# Service Bulletin

Bulletin No.: 16-NA-085

**Subject: New Design Cylinder Heads**

4509309

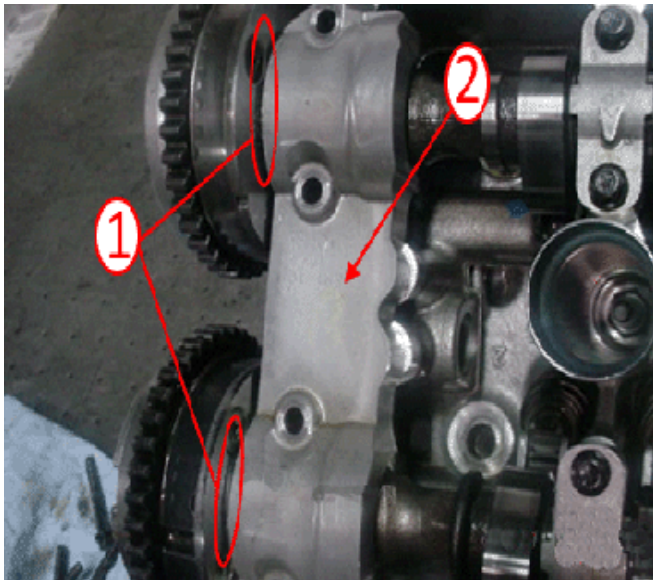
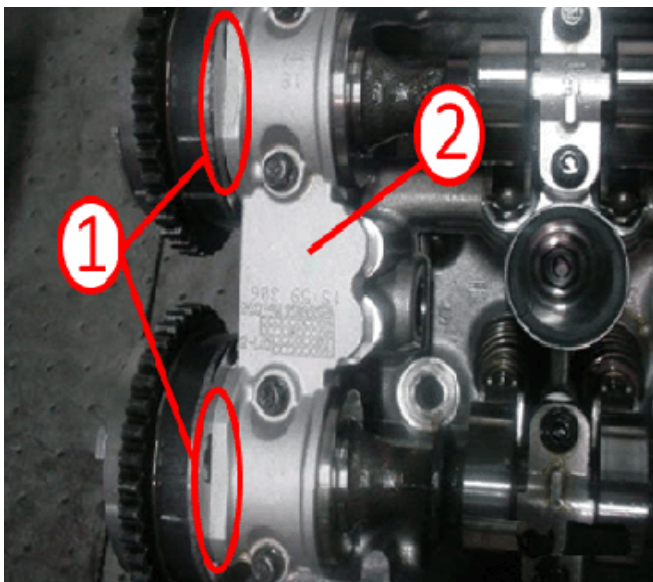
**Caution:** If you are using a 2011 new style "saddle cap" cylinder head, thrust washers are not to be used. The use of thrust washers on the new designed cylinder heads can cause damage to the cam shaft actuator, saddle cap and cylinder head.

Previously Designed Cylinder Heads used a thrust washer (1) between the actuators and cylinder heads.

The new cylinder heads have a saddle cap (2), which incorporated a thrust surface on the saddle cap, has been designed to reduce the tolerance between the camshaft actuator and cylinder head, eliminating the need for a thrust washer.

If replacing the cylinder heads for damage caused by the thrust washers, the cylinder heads must be replaced with a newly designed cylinder head.
